North Carolina Department of Environment and Natural Resources

DWQ Project # 12 0478
New Hanover County

Subject Property: **Global Laser Enrichment (GLE) Commercial Facility, Castle Hayne
Approval of 401 Water Quality Certification with Additional Conditions**

GLE Commerical Facility

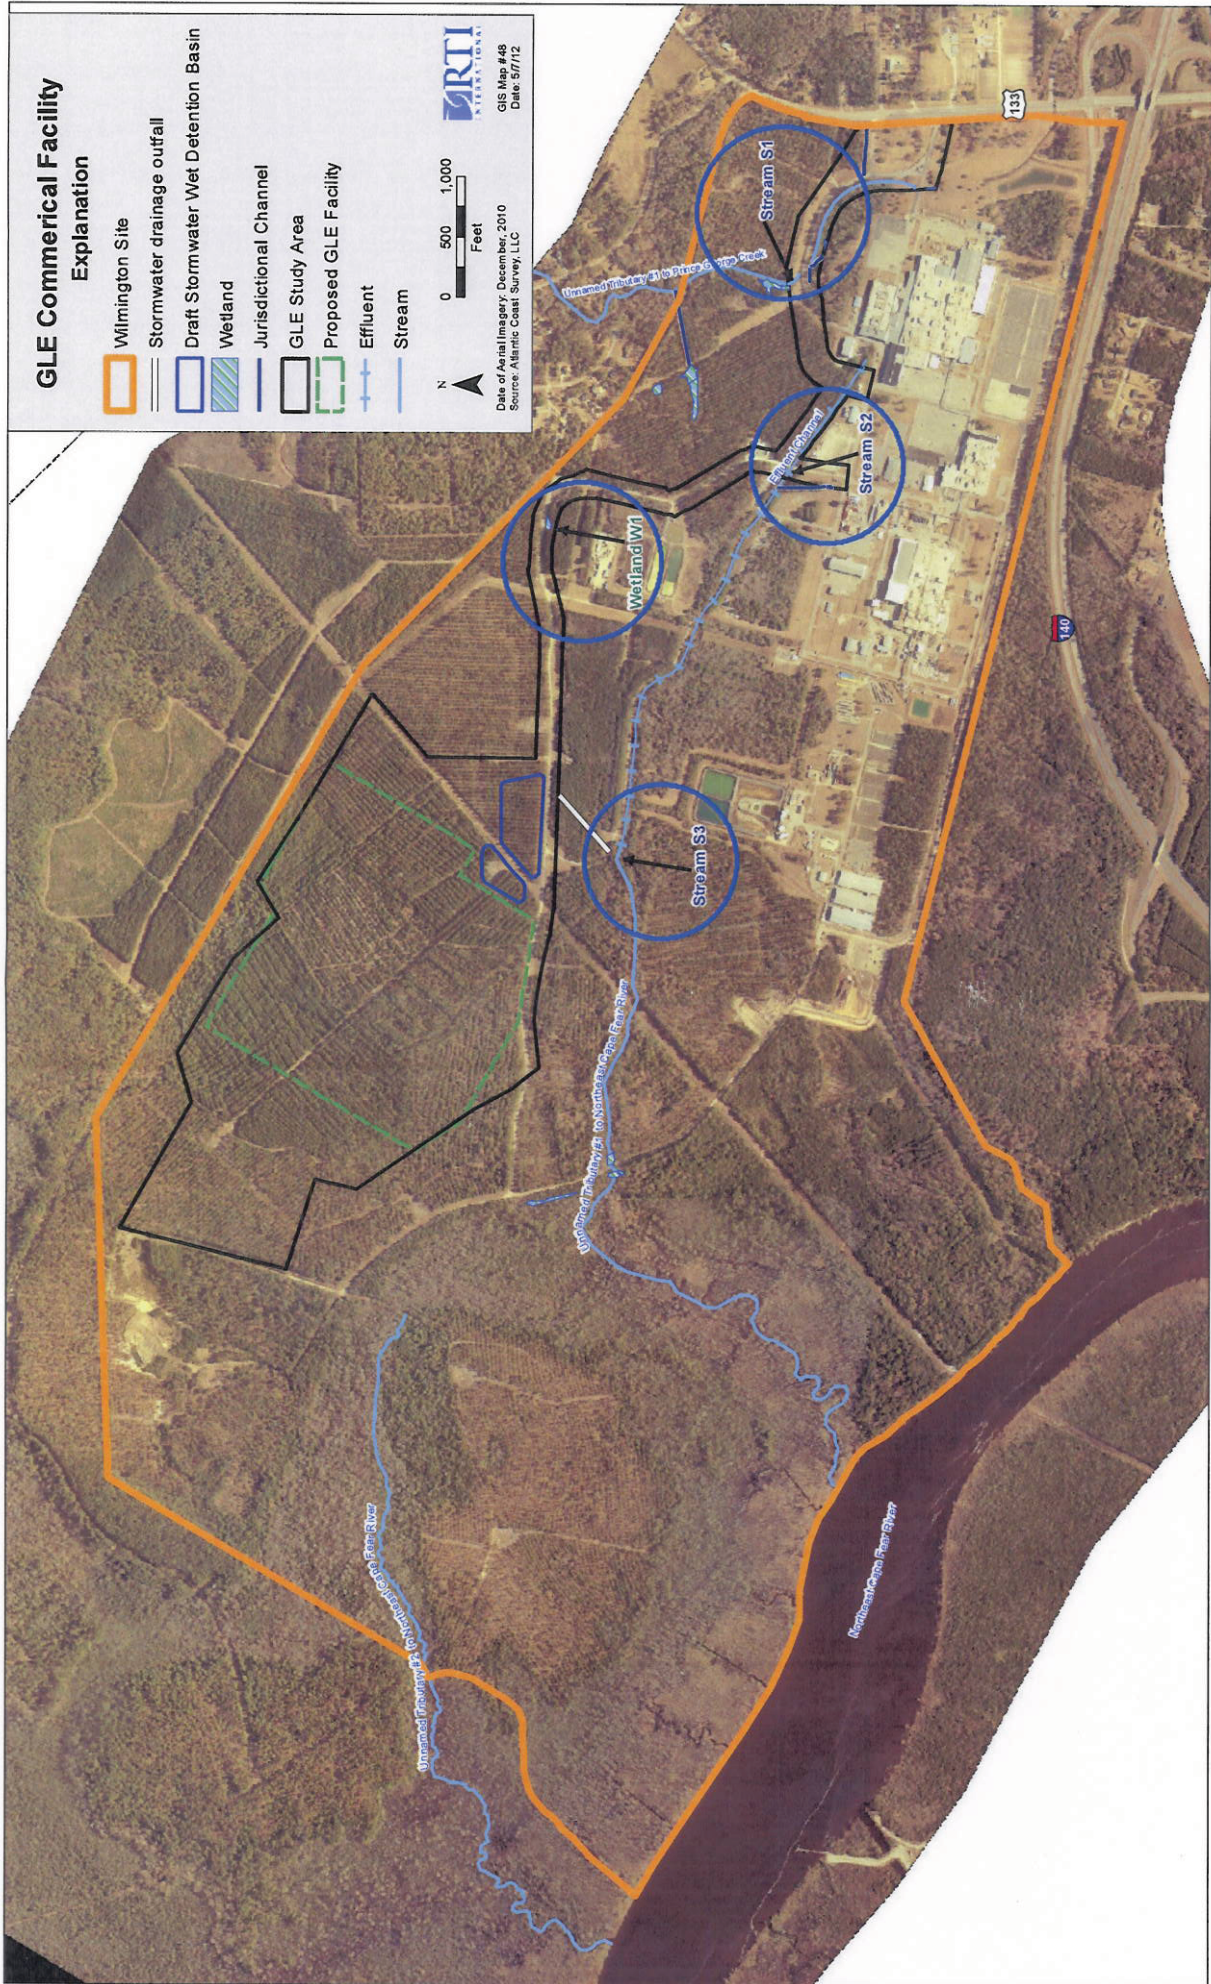
You have our approval, in accordance with the attached conditions and those listed below, to permanently impact 0.06 acres of a small basin wetland and 158 linear feet of streams and temporarily impact 56 linear feet of stream for the purpose of constructing the GLE Commercial Facility, as described within your Express application dated April 19, 2012 and received by the Wilmington Regional office (WiRO) as complete on May 23, 2012. After reviewing your application, it has been determined that the impacts are covered by General Water Quality Certification Number(s) 3890 (GC3890). **The Certification(s) allows you to use Nationwide Permit 39 when issued by the US Army Corps of Engineers (USACE).** In addition, you should obtain or otherwise comply with any other required federal, state or local permits before you go ahead with your project including (but not limited to) Erosion and Sediment Control, Non-discharge, and stormwater regulations. Also, this approval to proceed with your proposed impacts or to conduct impacts to waters as depicted in your application shall expire upon expiration of the 404 Permit.

Amount Approved (Units)	Plan Location or Reference
Wetlands Small Basin	(2807 sq ft) 0.06 acres	GLE Commercial Facility Explanation aerial (attached)
Stream Stream S1(permanent) Stream S2 (permanent) Stream S3 (temporary)	130 linear feet 28 linear feet 56 linear feet	GLE Commercial Facility Explanation aerial (attached)
Open Water	N/A
